SUMMARIZATION OF NEW APPENDICES (B, C, D, E, F, G, H)

REVISION: C (supersedes Rev B, dated June 2, 2026)

RE: Supplemental Public Comments and Risk Assessment regarding the Proposed 20 MGD Wastewater Treatment Facility

LOCATIONS UNDER CONSIDERATION: Sites 1 through 7 — Mann Road, Berea Church Road, and Coles Ferry Pike corridor, Lebanon, TN

Exhibit C-1: 0.5-mile, 1.0-mile, and 2.0-mile rings centered on 3230 Mann Road, plotted on the TDEC Water Wells Desktop Application map. Each dark dot represents a permitted private water well in the TDEC database.

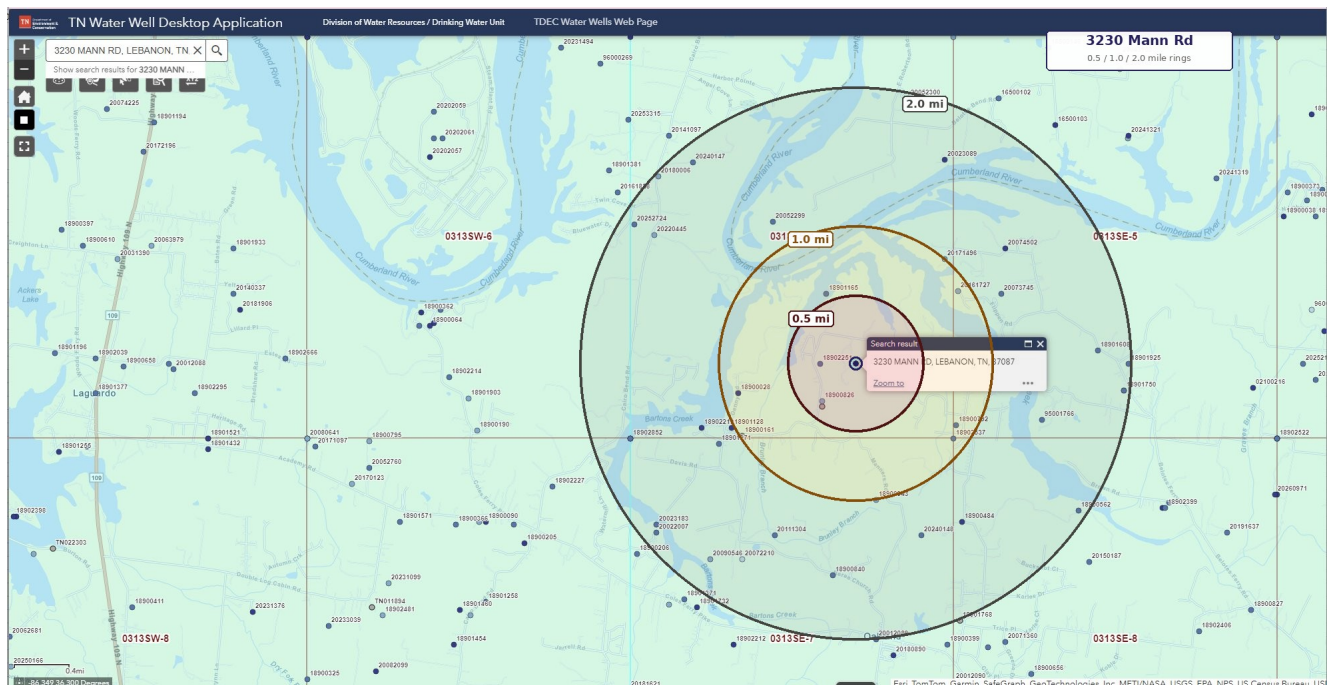
A query of the Tennessee Department of Environment and Conservation (TDEC) Water Well Locations public database identifies **a minimum of 38 permitted private wells within the 2-mile contamination radius** surrounding the proposed Mann Road and Berea Church Road footprint. Of these:

- **6 wells are located within 0.5 miles** of a proposed site, including a well at 1079 Berea Church Road (Coster) situated approximately 850 feet (0.16 mi) from the Mann Road site;
- **16 wells are located within 1.0 mile** of a proposed site;
- **38 wells are located within 2.0 miles** of a proposed site, the outer boundary of the karst contamination radius identified in Section VI.

The geographic distribution of these wells, with concentric 0.5-mile, 1.0-mile, and 2.0-mile rings, is depicted in Exhibit C-1 below. Recorded uses include residential drinking water (32 wells), agricultural and irrigation (9 wells), and geothermal heat pump (3 wells). The Site Selection Committee has not, to the petitioners' knowledge, entered these figures into the public record.

- Formally request a hydrogeological study from a qualified third party documenting (or refuting) hydraulic connectivity between the proposed site footprint and the LUD well field;
- Require coordination with the LaGuardo Utility District Board of Commissioners as a prerequisite to any further consideration of the Mann Road and Berea Church Road addresses;
- Enter the well-count data and accompanying ring map (Exhibit C-1) into the official public record of the site selection proceedings, and supplement it with an independent staff verification against the most current TDEC Water Well Locations database;
- Provide written notification to each identified well owner, and to all LUD ratepayers, of the proposed siting and the karst-aquifer contamination pathway described in Section VI of the principal statement.
